Re: Sandia Federal Credit Union/ 1100 Rio Grande Blvd. NW
Request for Certificate of Occupancy
Transportation Development Final Inspection
Engineer's Stamp dated 11-23-21 (H13D109A)
Certification dated 10-23-23

ENGINEER'S SEAL 11/23/2021	SANDIA LAB FCU RIO GRANDE + I-40 TRAFFIC CIRCULATION LAYOUT	DRAWN BY LN
RONALD R. BOHANNAN P.E. #7868	TIERRA WEST, LLC 5571 MIDWAY PARK PL NE ALBUQUERQUE, NEW MEXICO 87109 (505) 858-3100 www.tierrawestllc.com	DATE: 11-19-2021
		DRAWING: 2012100-SP
		SHEET # C1
		JOB # 2012100

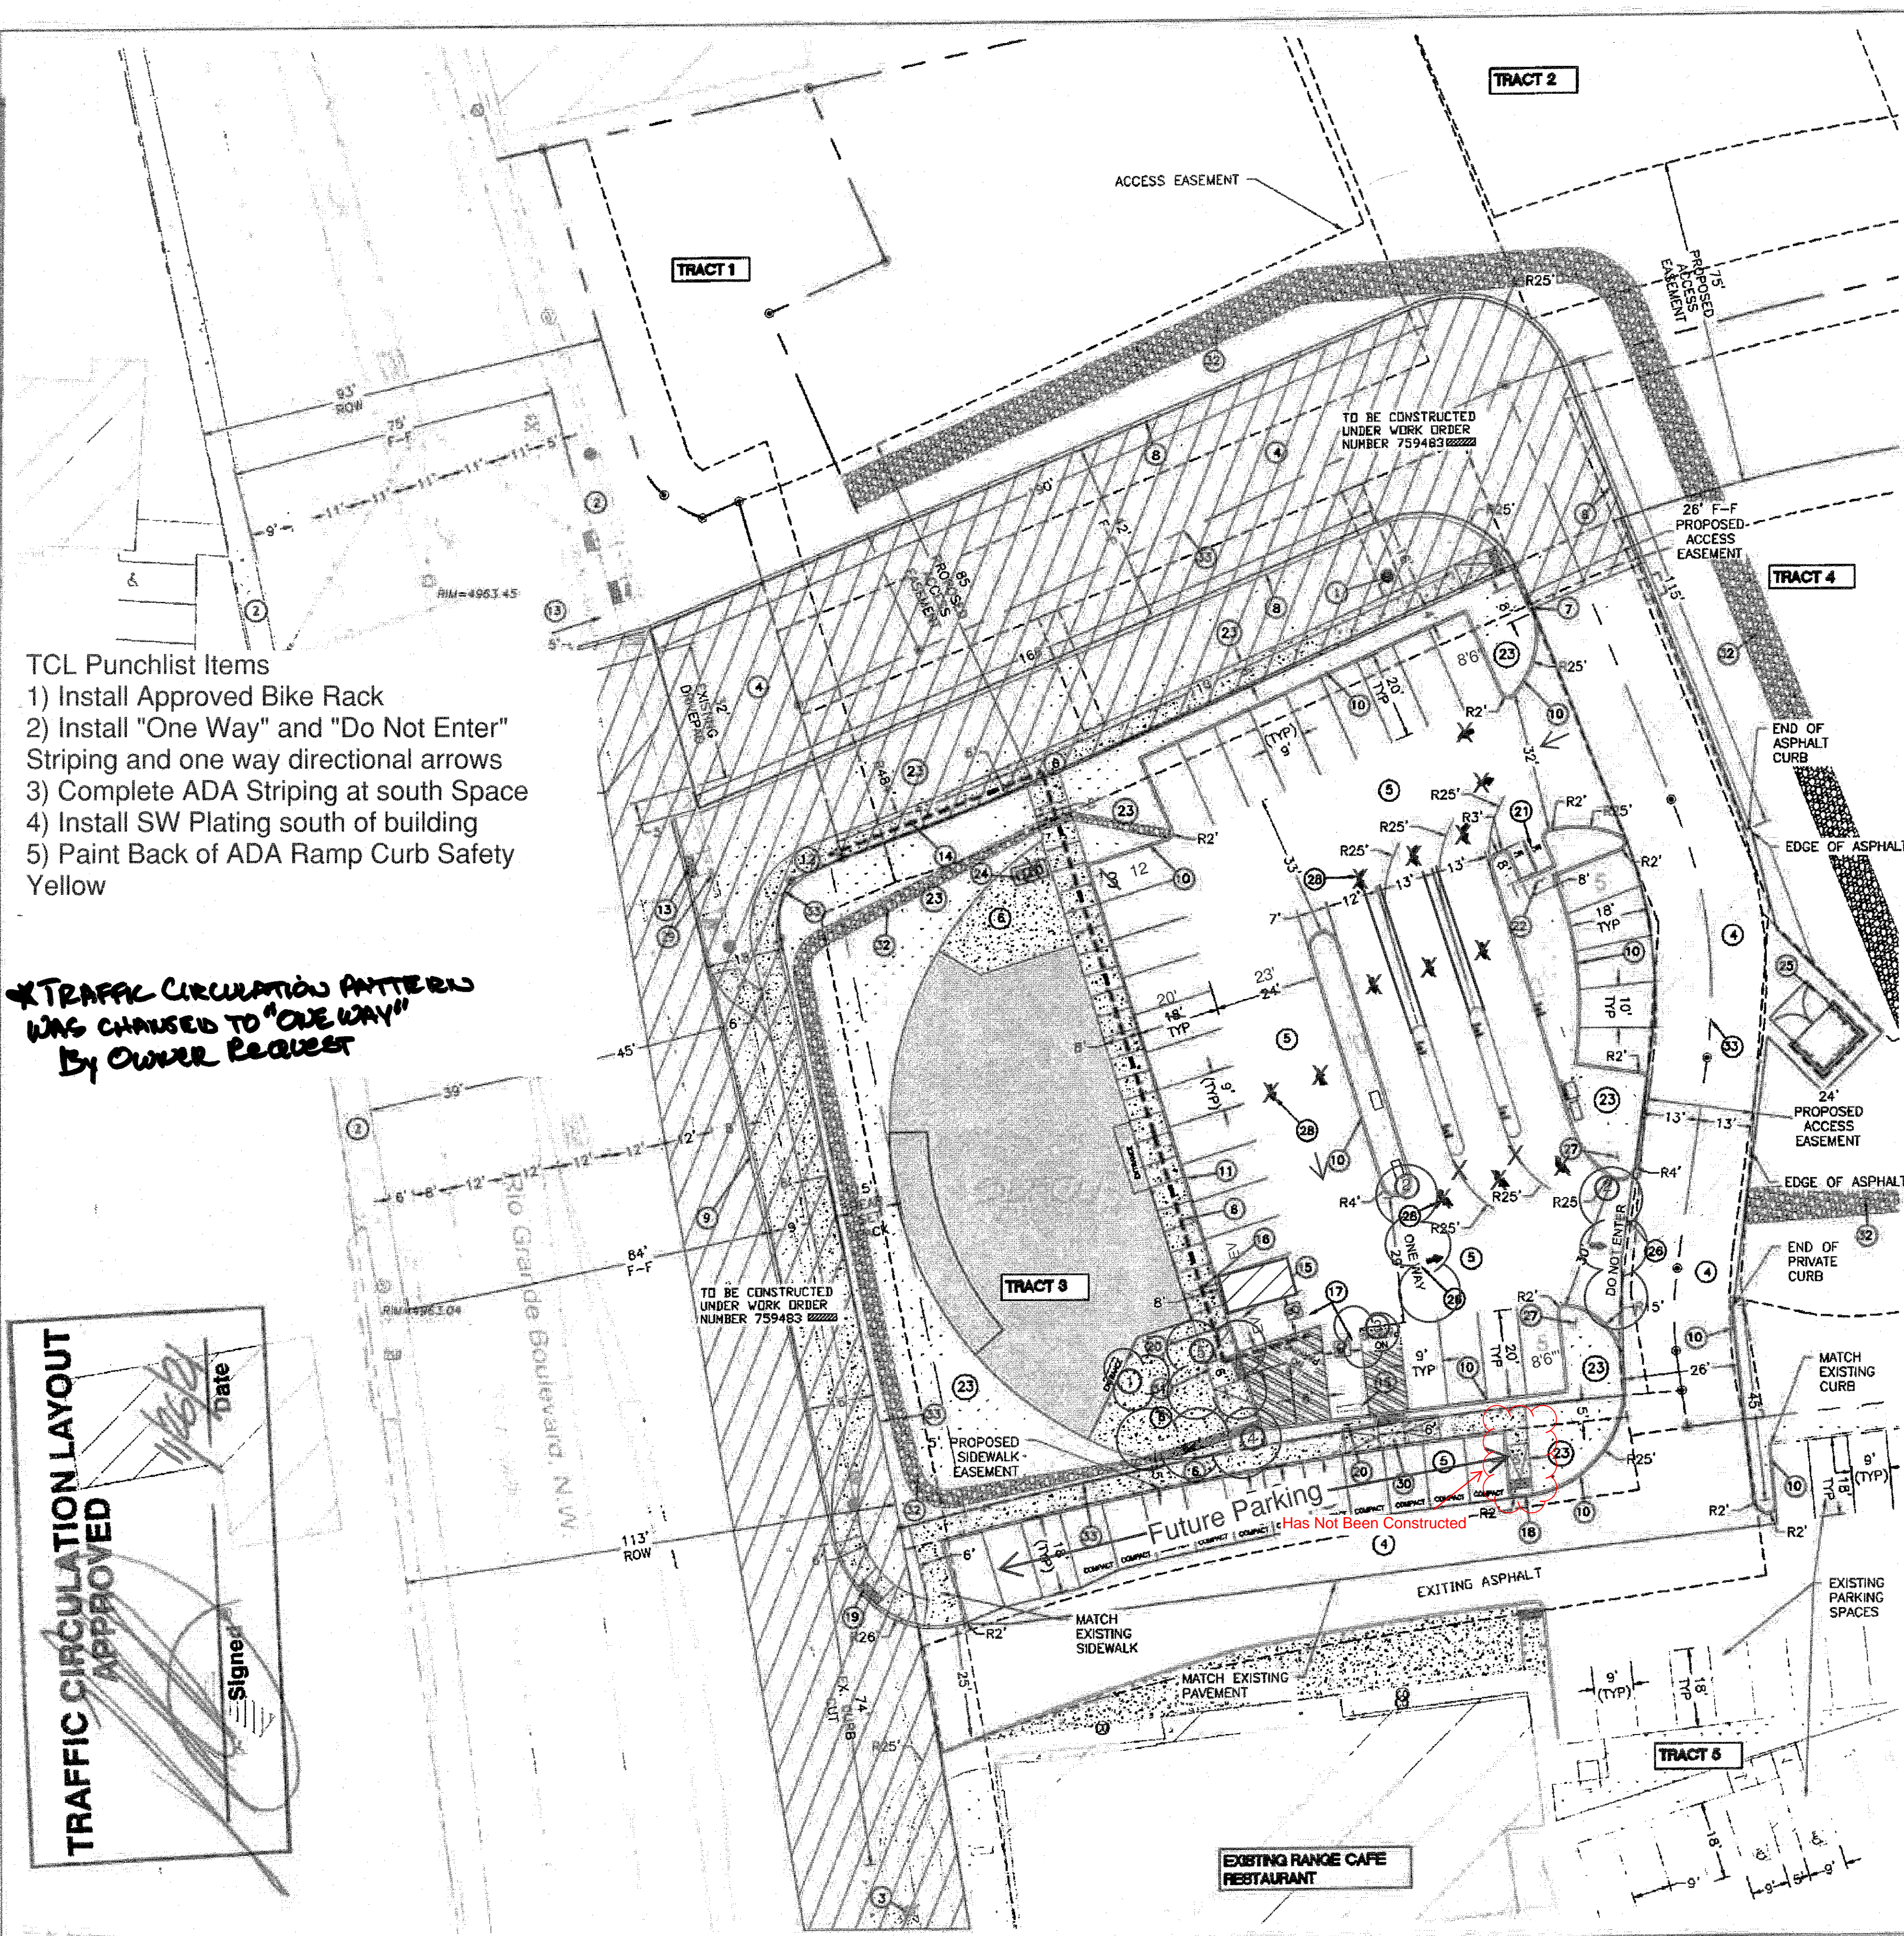
CONDITION OF FINAL C.O. APPROVAL:
N.O. CPN 759483 BE COMPLETED, &
APPROVED/ACCEPTED

- TCL Punchlist Items
- 1) Install Approved Bike Rack
 - 2) Install "One Way" and "Do Not Enter" Striping and one way directional arrows
 - 3) Complete ADA Striping at south Space
 - 4) Install SW Plating south of building
 - 5) Paint Back of ADA Ramp Curb Safety Yellow

TRAFFIC CIRCULATION PATTERN
WAS CHANGED TO "ONE WAY"
BY OWNER REQUEST
